# NEW YORK STATE DEPARTMENT OF ENVIRONMENTAL CONSERVATION

Division of Water, Bureau of Water Compliance

October 23, 2024

## **NYSDEC Scenario 1 Issues (Solar Memo):**

### FLOW DIFFUSER

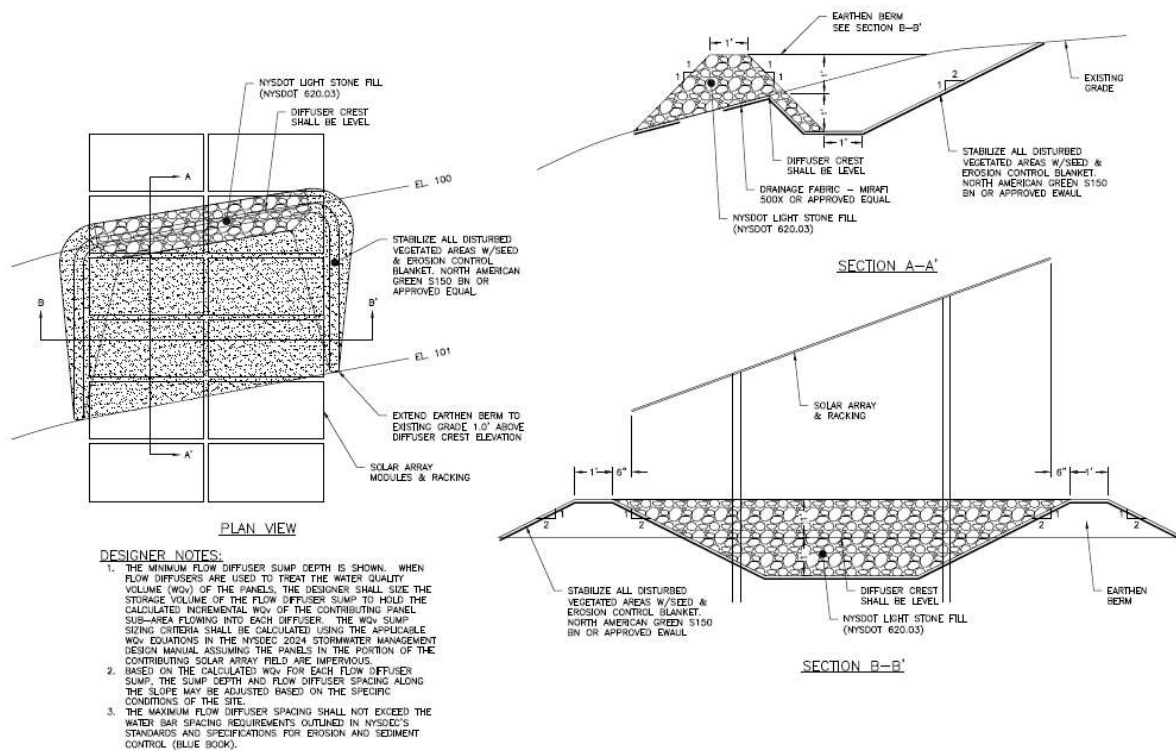
If the panels are placed on slopes greater than 10%, what is acceptable to demonstrate developers are designing a site with effective stormwater management practices? In our experience we have proposed the following accepted solutions:

To date, the majority of our solutions have been gravel level spreaders/diaphragms on slopes above 10%, generally spaced throughout the solar panel area site using the NYSDEC blue book spacing for like water bars.

In steep panel areas (e.g. in excess of ~20% slopes), we have had instances where we provided additional attenuation (reducing runoff rates further than what is required by the Stormwater Design Manual) in order to satisfy Town engineers.

An alternative “engineered” solution pioneered by Marathon Engineering have been flow diffusers which he has used at staggered locations primarily beneath the panels to catch water leaving the panels and slow it down while avoiding most of the drive aisles for construction (snip below).

NYSDEC acknowledges that well-designed projects on slopes steeper than 10 percent have successfully implemented some of the alternative practices mentioned such as flow diffusers and stone diaphragms. The flow diffuser detail (above) from Marathon Engineering has been applied on several sites. If there are instances that trigger 60 day review, please note that it will aid in review if you can provide examples of previous projects that this practice has been approved on.

**Diagram 1: NYSDEC Solar Plan View** N.T.S.

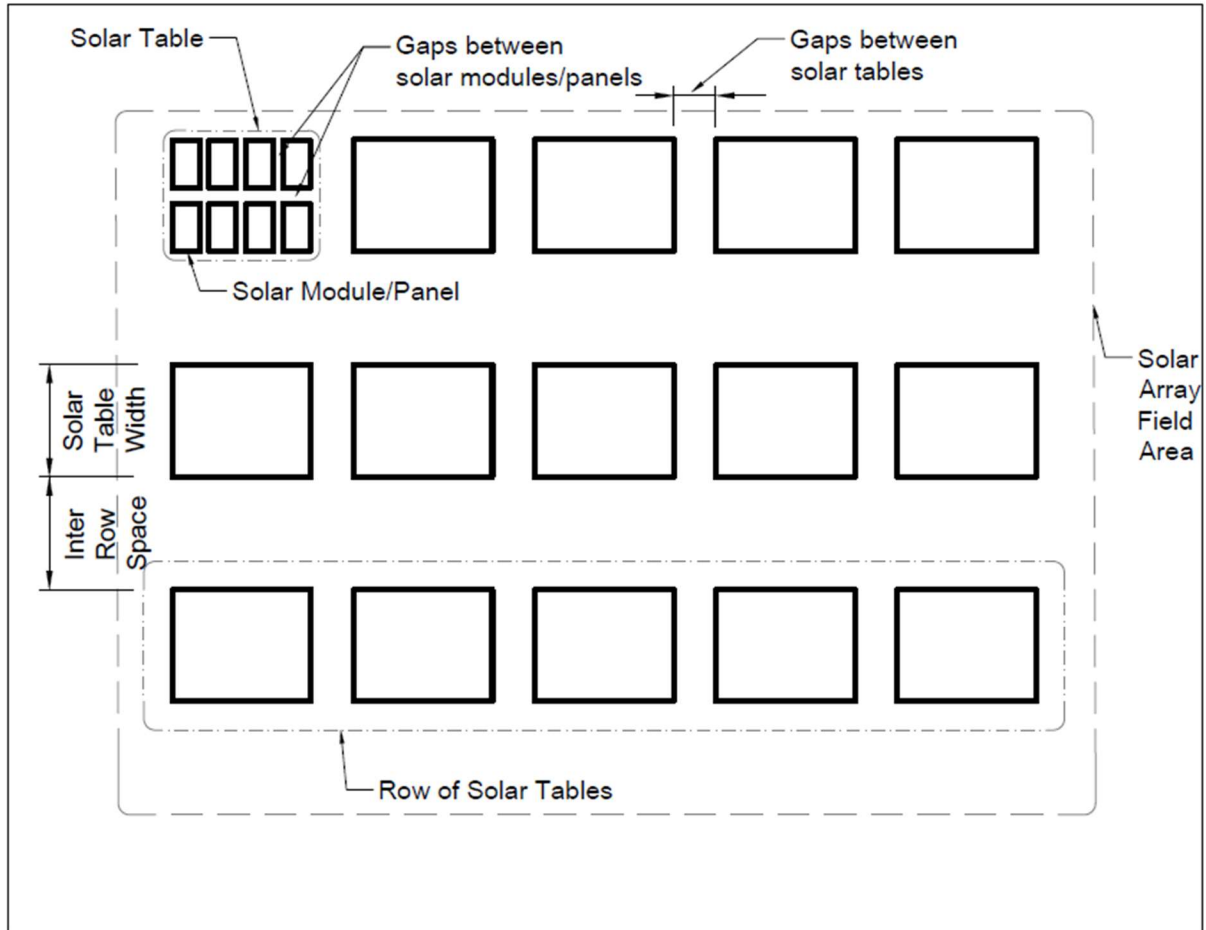
2. NYSEIA Question

Please explain what you mean by the panels need to be spaced apart.

Panel spacing is consistent with the concept of disconnection of impervious area (Section 5.3.4 of the 2024 White Book) and is an important component to consider when avoiding erosive conditions. Disconnection can be achieved through adequate spacing of panel rows over areas of well-established vegetative cover (see Diagram 2: NYSDEC Solar Profile View: Inter-Row Space). For the designer to meet the intent of disconnection, a design should consider the largest solar panel width, considering all solar panel rotations/positions

and provide that width as the minimum spacing downgradient of every row of solar panels in the solar array field area. If inter-row space requirements are insufficient, infiltration is less likely, resulting in panels that are more likely to create concentrated flow paths and perform as impervious. For solar array field areas that have insufficient spacing for infiltration, the disconnection credit for runoff reduction would not be applicable. As a result, the SWPPP would need to address post-construction stormwater management control practices.

**Diagram 3: NYSDEC Gravel Diaphragm Along the Contour N.T.S.**

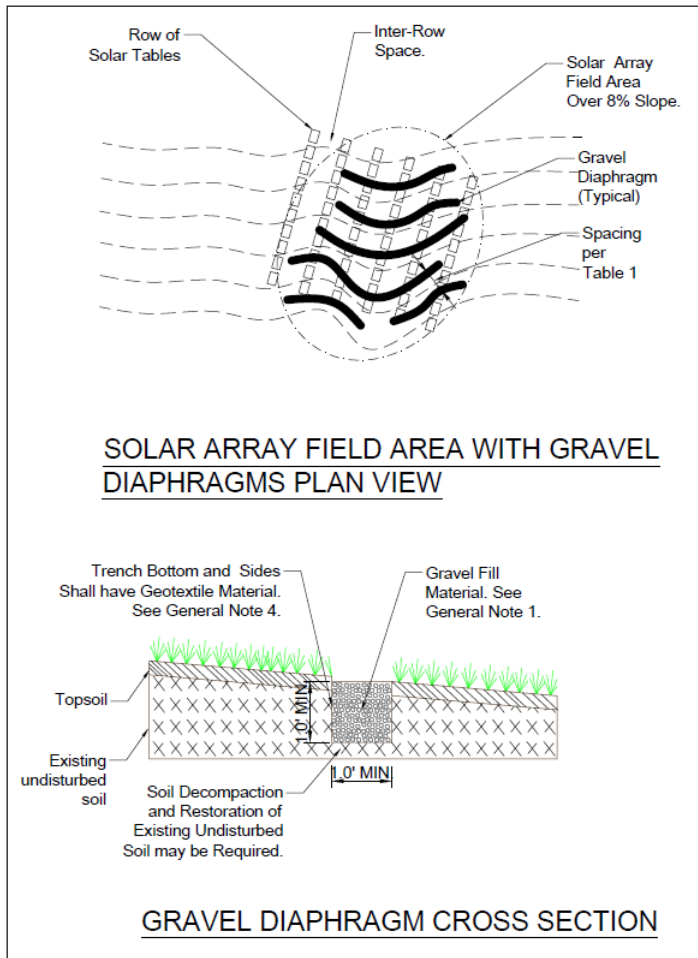
4. NYSEIA Question:

If panels aren't "generally installed along the contour" does that mean the area of solar panels wouldn't be allowed to function as a filter strip?

In accordance with Table 5.7 of the 2024 White Book, it is noted that there are slope limitations for the filter strip. They can only be used on slopes less than or equal to 8%. This is to ensure that sheet flow can be maintained. If slopes are greater than 8%, then there are two main alternatives:

- a) Design and implement permanent engineered practices from the Blue Book and White Book or use the NYSDEC Gravel Diaphragm detail (Diagram 3) along the slope/contour, to reestablish and maintain sheet flow, which will meet RRv and WQv requirements. It is worth noting that the use of the gravel diaphragm has been effectively implemented in many scenarios. OR

DRAWING TITLE:  
**LIMITED USE PERVIOUS ACCESS ROAD DETAIL**

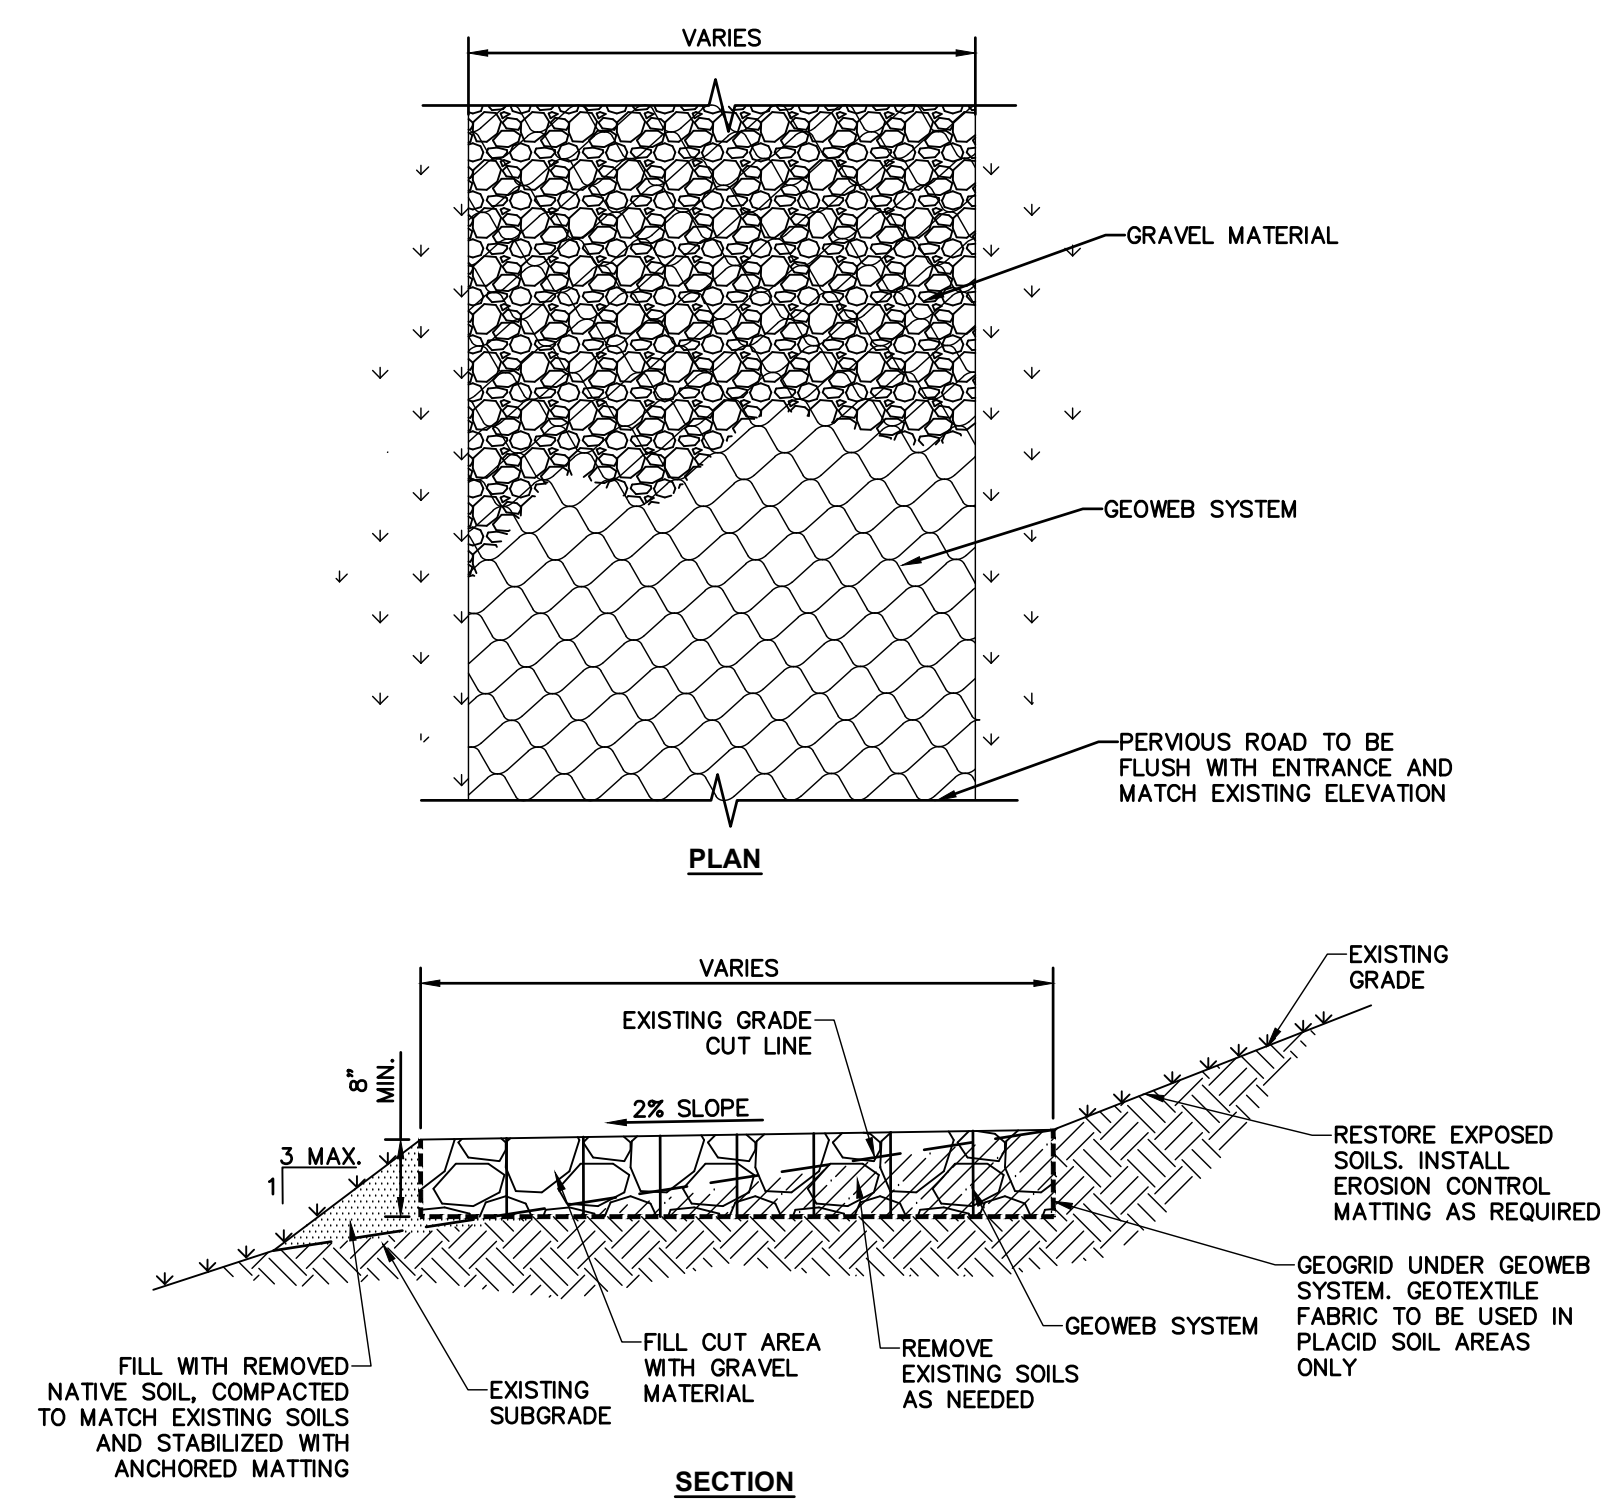
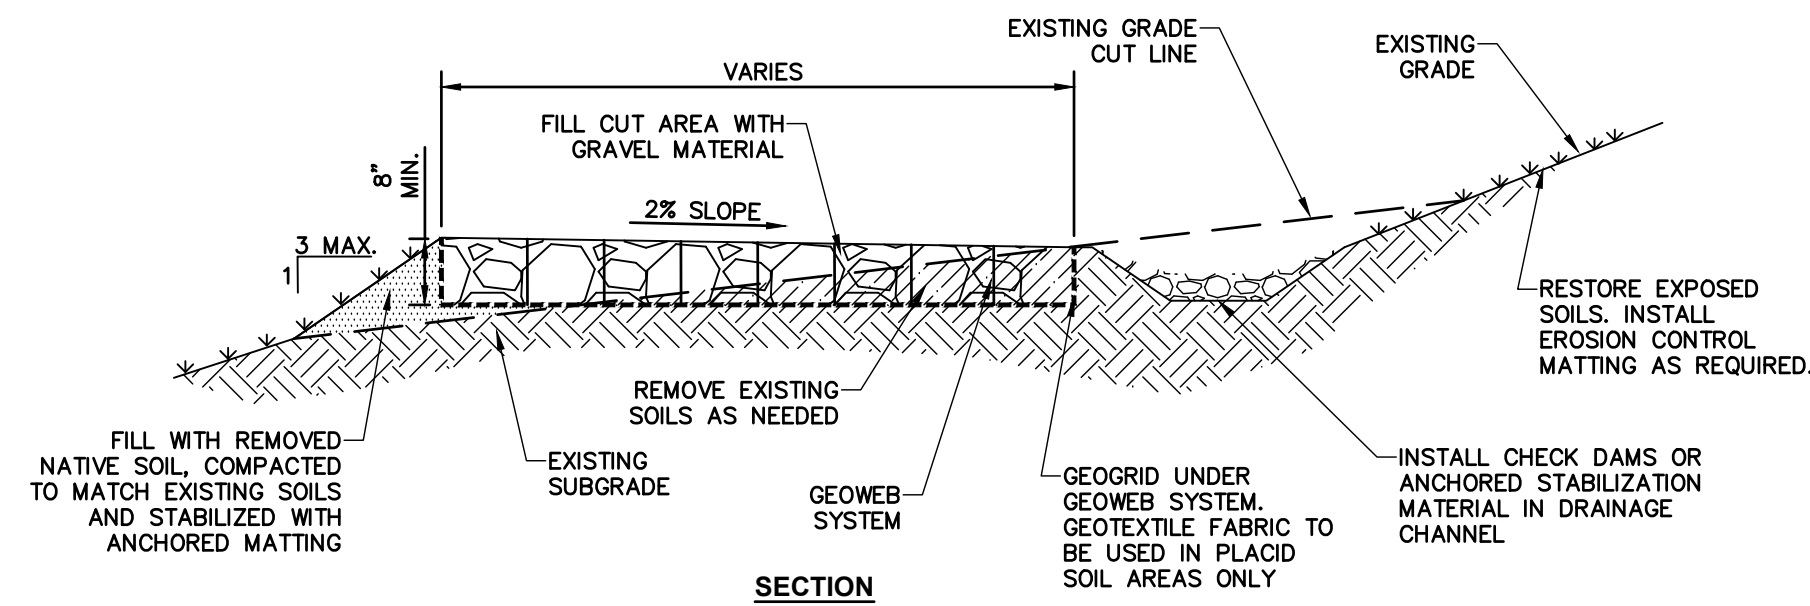
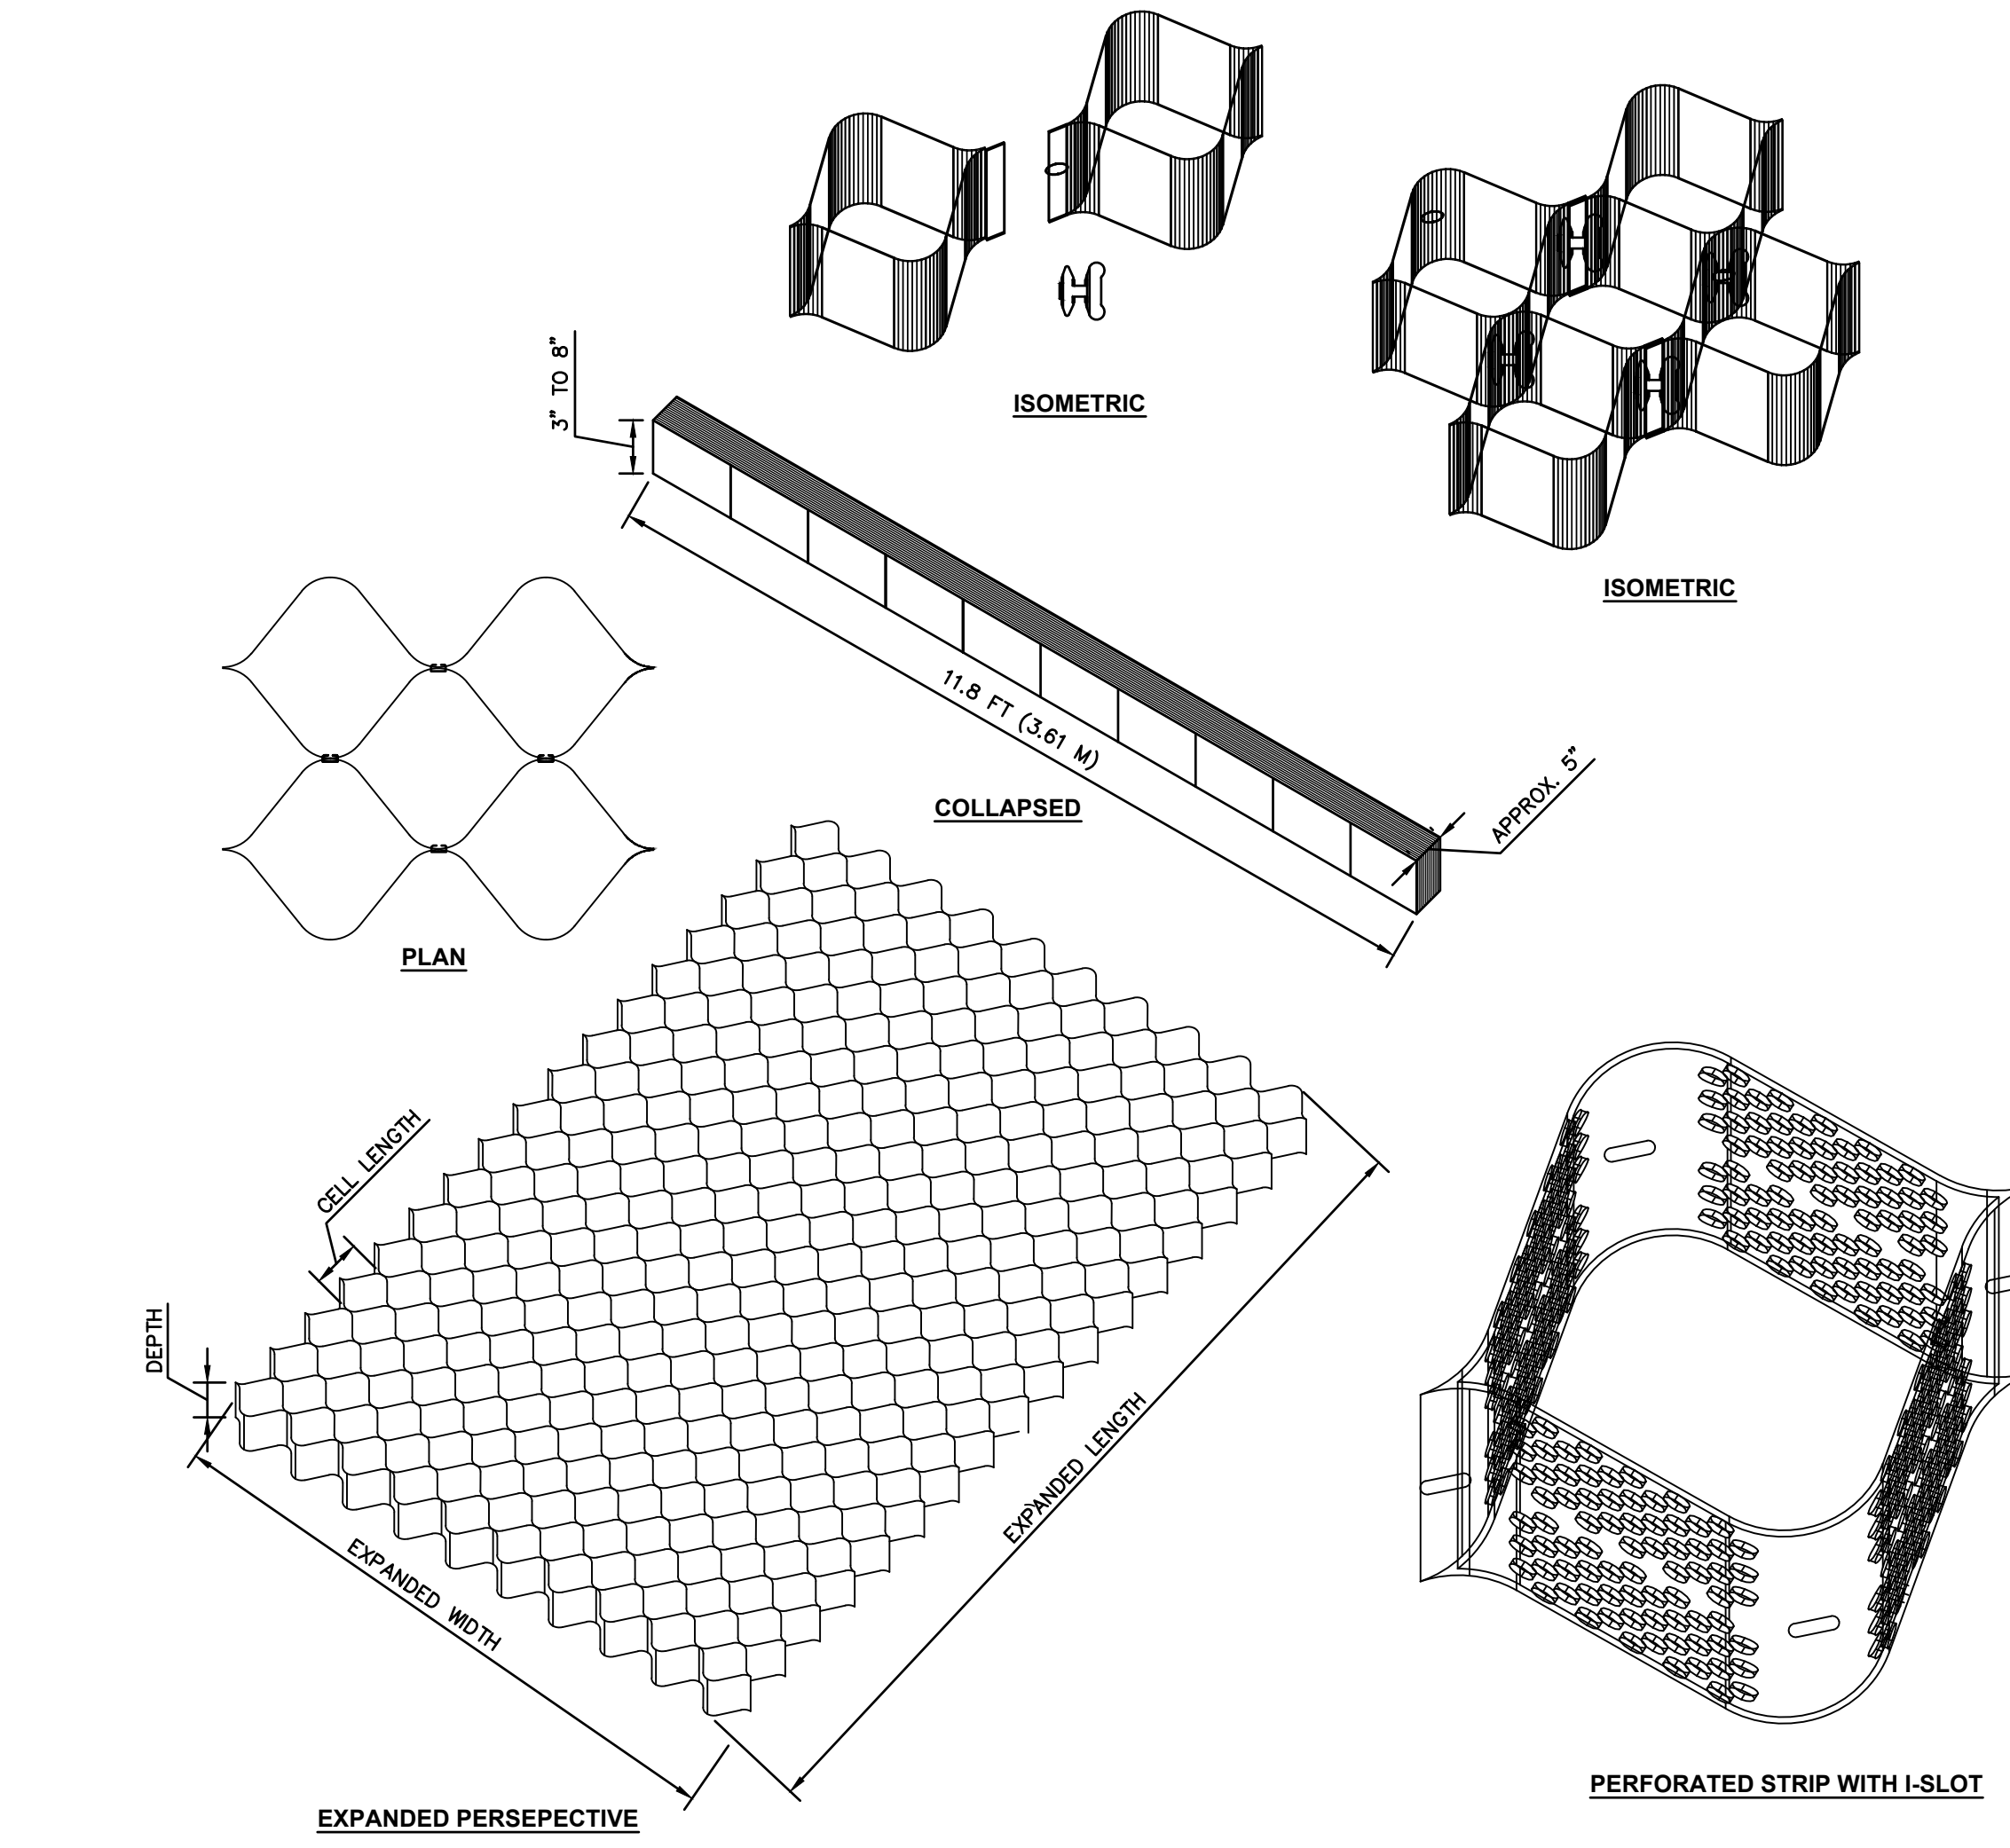
7. NYSEIA Question:

Does DEC require pervious access roads into the solar facility? If so, is there a typical you can provide for developers to reference?

No, pervious access roads are not required by the CGP and are not listed in the 2024 White Book and therefore are not required on renewable energy sites. It is worth noting that on many solar sites, the pertinent design requirements for the pervious access road detail cannot be met. For example, there are slope limitations. Cross slopes cannot exceed 6% and the longitudinal slope should not exceed 15%. Additionally, these roads should not be utilized during construction as it may impact soil or other conditions and require testing and re-construction to be effective as a pervious feature. Many sites do not have enough available area to construct both temporary and permanent roads in separate footprints. Finally, the limited use pervious access road cannot be constructed or used until all areas subject to runoff onto the road have achieved final stabilization. Attached, please find a copy of a typical limited use pervious access road detail that has been accepted in SWPPP review for your reference.
